Urgent Field Safety Notice
3mensio Workstation (Vascular – Fenestrated)
Version (10.6, 10.6 SP1, 10.6 SP2, 10.6 SP3, 10.6 SP4, 10.7, 10.7 SP1)

The purpose of this letter is to advise you that Pie Medical Imaging is issuing an urgent Field Safety Notice regarding the clock position visualization in the fenestration diagram in 3mensio Workstation 10.6 (Vascular – Fenestrated layout) or 3mensio Workstation 10.7 (Vascular – Fenestrated layout).

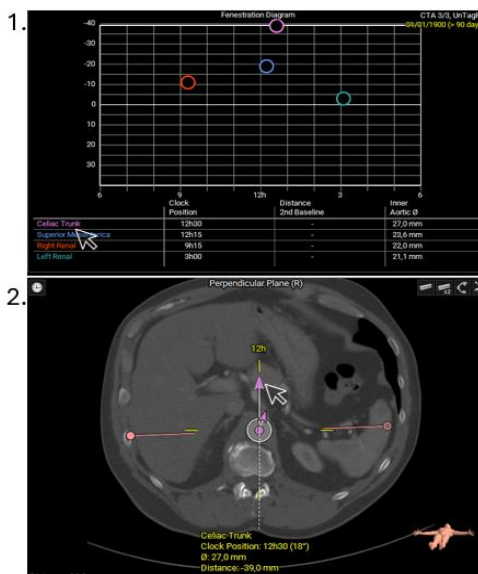
Observed behaviour: In the fenestration diagram only the adjusted clock measurement is updated to the new 12h position. The other clock measurements are not updated relative to the new 12h position

Fenestrated analysis with clock measurements started in 3mensio Workstation 10.6 (12h in AP direction)	Changing 12h position of a single clock measurement → results in an updated fenestration diagram with all clock measurements relative to this 12h
Observed		
	Opening a fenestrated analysis with clock measurements	Changing 12h position of a single clock measurement → Only the adjusted clock measurements is updated in the fenestration diagram.

In case you open a session state with saved clock measurements created in **3mensio Workstation 10.6** and there is a need to adjust the **12h position** for the clock positions, make sure to update **all** individual clock measurements in the perpendicular plane by the following steps:

1. Click on the clock position.
2. Update the 12h pointer of the clock in the perpendicular viewport.
3. Perform step 1 & 2 for all clock measurements in the analysis.

After updating all 12h pointers, the information shown in the fenestration diagram is correct and functionality is restored.
